Support Document for the Revised National Priorities List Final Rule – Pierson's Creek

**Support Document for the
Revised National Priorities List
Final Rule
Pierson's Creek
September 2014**

**Site Assessment and Remedy Decisions Branch
Office of Superfund Remediation and Technology Innovation
Office of Solid Waste and Emergency Response
U.S. Environmental Protection Agency
Washington, DC 20460**

Figure 1 – Map of the surface water pathway in Pierson's Creek. Map includes the zone of contamination, wetland frontage, surface water and sediment sample locations and the location of the Troy Facility.

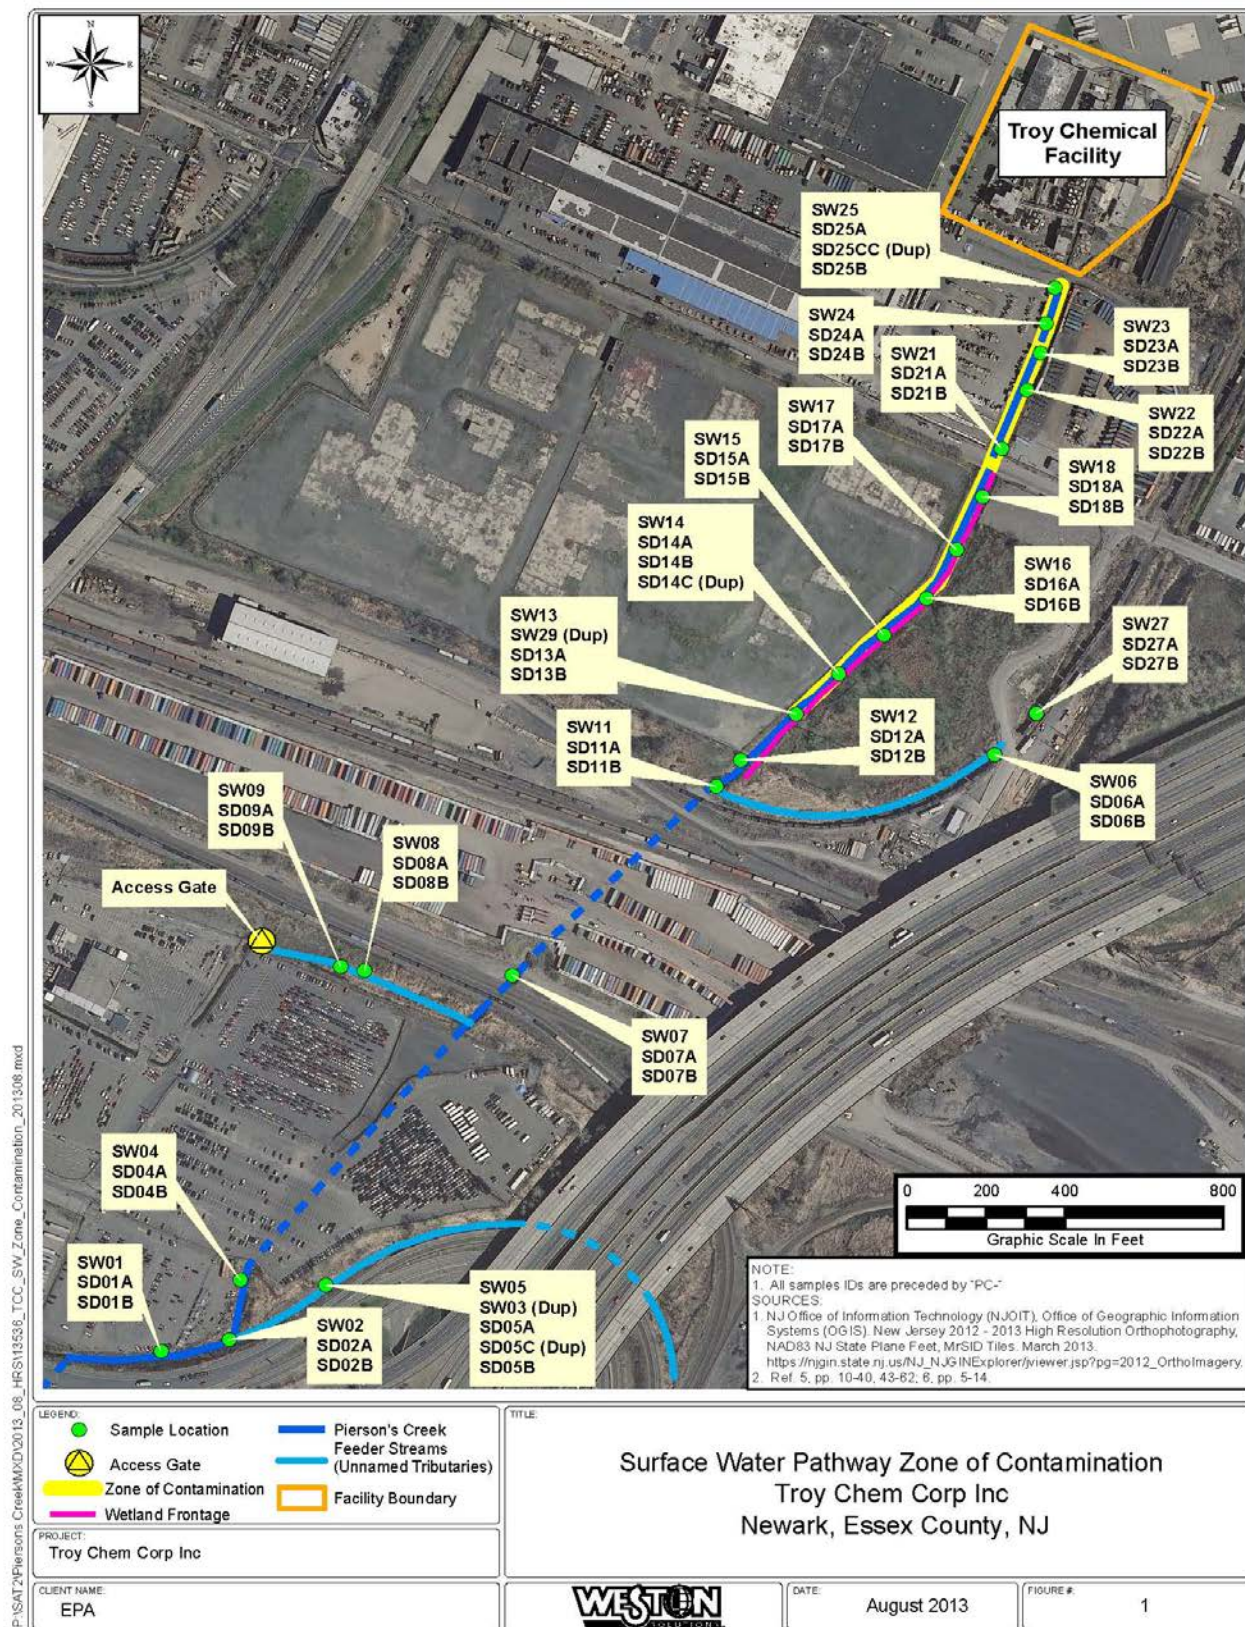
Troy also questioned the adequacy of documentation included in the HRS package, commenting insufficient documentation of the wetland delineation was provided to allow for Troy to "meaningfully comment on the proposed listing." Troy and 429 Delancy both challenged the presence of wetlands contiguous to Pierson's Creek, commenting that the stretch of Pierson's Creek along the 429 Delancy property has been designated as "state open waters" by NJDEP, and that such designation means that stretch is not a wetland. Troy took further issue with the wetland delineation along Pierson's Creek, commenting:

The stretch of the wetlands within the zone of actual contamination corresponds to the 0.15-mile length scored in the HRS documentation record at proposal. Figure 1 of this support document shows that the zone of actual contamination (signified by the yellow line) extends from upstream of Delancy Street to the farthest downstream observed release sample, SD13B. (Thus, the 0.15-mile length corresponds to the distance where the wetland [purple line] overlaps the zone of actual contamination [yellow line] on Figure 1 of this support document)

- Field logbook information contained in Reference 5 (and detailed in section 3.18.1, Wetland Length, of this support document) provides the basis for the extent of wetlands identified.
- The extent of wetlands identified is plotted on Figure 1 of this support document, shown as a purple line.

⁹ See Figure 1 of this support document. The wetland frontage included in the HRS evaluation ends at sample SW13 (end of the zone of contamination).

Figure 2 – Map showing the wetland frontage determined to be present in Pierson's Creek. This map shows the locations of the soil borings and flag locations that were used in the October 2012 wetland delineation.

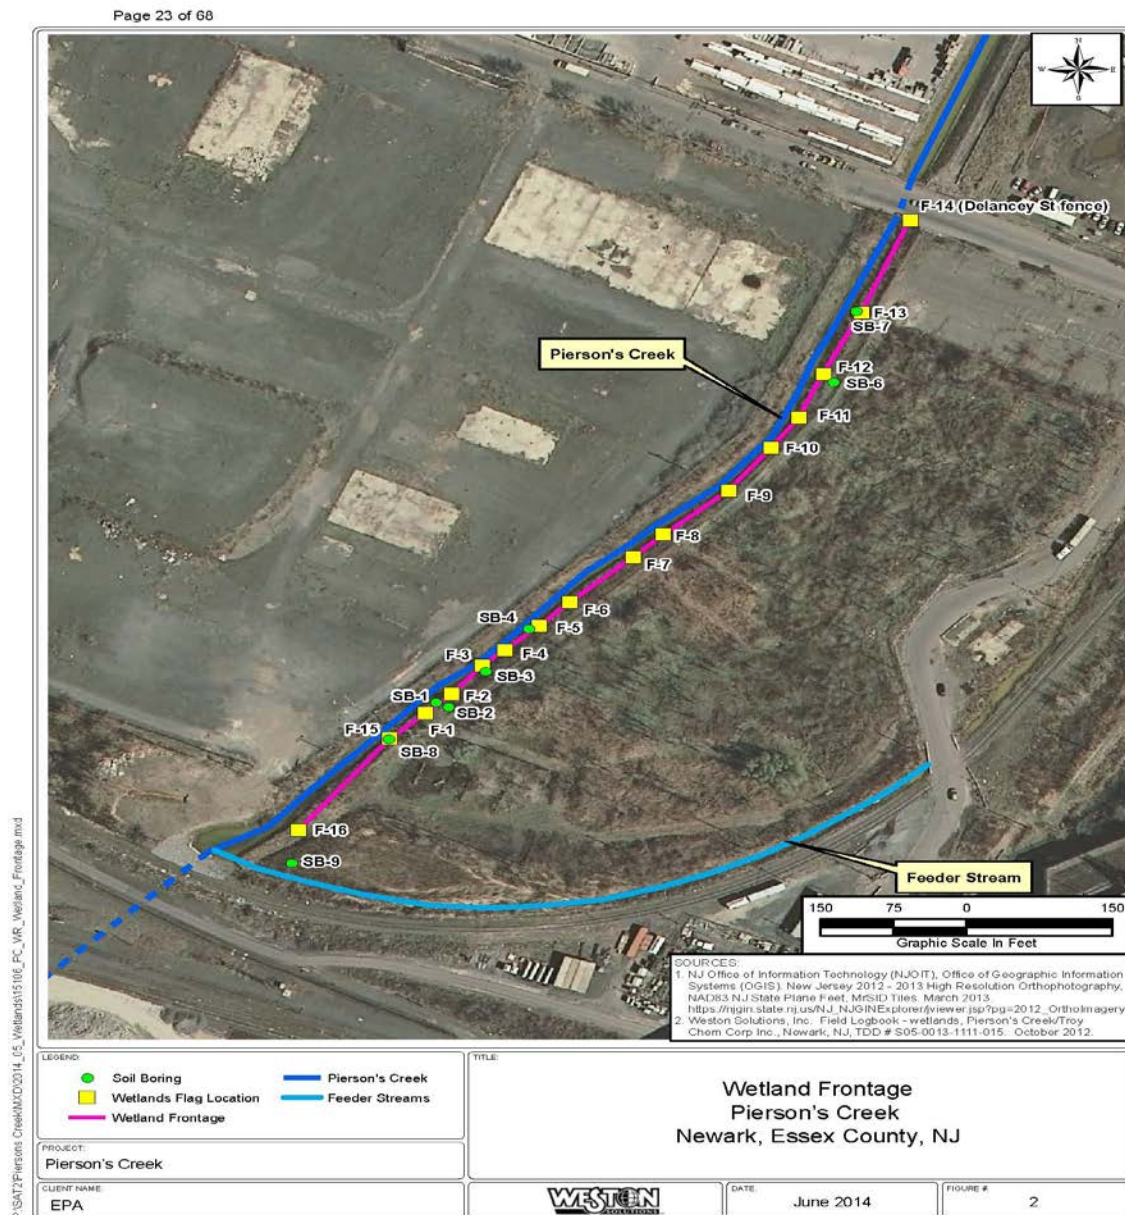
44 of Reference 5 of the HRS documentation record at proposal noted that “flag locations F-1 to F-14 delineated the edge of the wetland along the creek. Soil boring locations SB-2, SB-3, SB-5, SB-6, and SB-8 showed the upland areas just upslope from the wetland.”

In response to these comments, the EPA verified the intent of the authors of the October 2012 wetland delineation presented in Reference 5 of the HRS documentation record at proposal. This verification is contained in a June 2014 Wetland Delineation Report (included as Attachment 2 of this support document) that confirmed the conclusions of the October 2012 wetland delineation (see pages 13 and 23 of Attachment 2 of this support document). Figure 6 on page 23 of Attachment 2 of this support document contains a plot of the flag locations.

Finally, as shown on page 43 of Reference 5 of the HRS documentation record at proposal, following the field assessment the wetlands scientist describes the wetlands extent, concluding that “there is a small fringe wetland, at the base of a steep slope, along the east edge of Pierson’s Creek, from the Conrail property north across the 429 Delancy property to Delancy Street.” This determination made by the wetlands scientist is the basis for the wetland extent described in the HRS documentation record at proposal (this extent is shown as a purple line on Figure 3 of the HRS documentation record at proposal, also cited in text quoted above [See also Figure 1 of this support document]).
